U.S. NUCLEAR REGULATORY COMMISSION

Report No. 50-461/90025(DRP)

Facility Name: Clinton Power Station

Inspection Conducted: November 20 through December 14, 1990

Figure 1 - Simplified Arrangement Drawing of RCIC and RHR Containment Penetrations

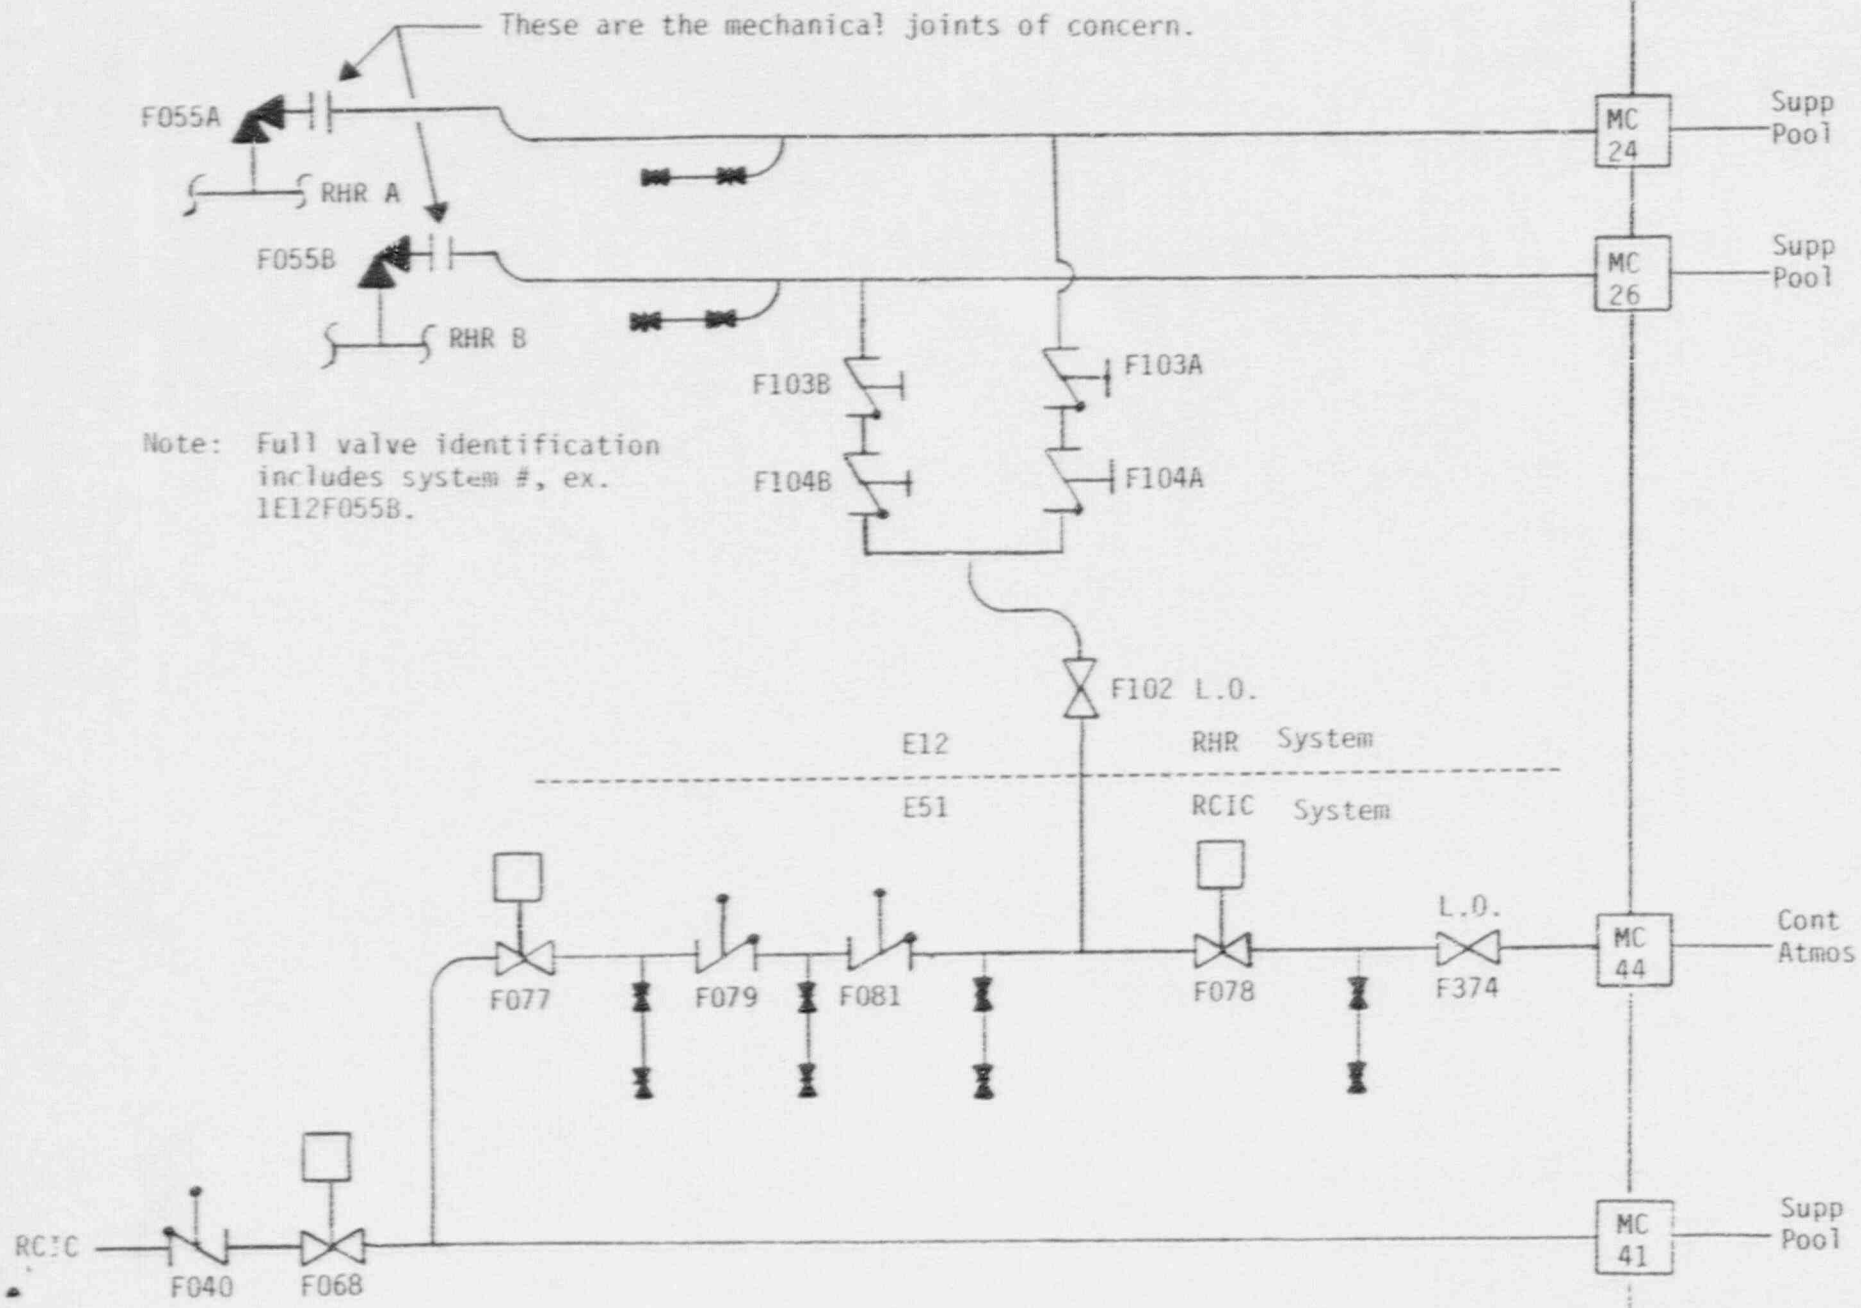
During a review of maintenance activities, the inspectors identified a concern related to the design of primary containment, with regard to valves 1E12F055A and 1E12F055B (see figure 1).

These valves are safety valves which are designed to protect the RHR system from overpressure conditions. They have a setpoint of 500 psig and discharge into the suppression pool (inside containment). The valves are physically located in the RHR HX rooms and are installed with flanged mechanical joints, as opposed to welded joints. The inspectors concern relates to the flanged joints on the discharge of the valves and not to the valves themselves. The inspector postulated that these flanged joints could be exposed to containment atmosphere via valve 1E12F102 if valve 1E51F078 was to fail open. If that was correct then the joints should be designed in accordance with the requirements of 10 CFR Part 50, Appendix A, General Design Criteria 54, in that the reactor containment shall be designed to permit periodic testing at containment design pressure of the leaktightness of penetration which have resilient seals. This question will be followed as an unresolved item (461/90025-04(DRP)). Additionally, the inspector questioned if the flanged joints had been tested in accordance with the requirements of 10 CFR Part 50, Appendix J, Paragraph III.B for testing of Type "B" containment penetrations. This question will be followed as an unresolved item (461/90025-05(DRP)).
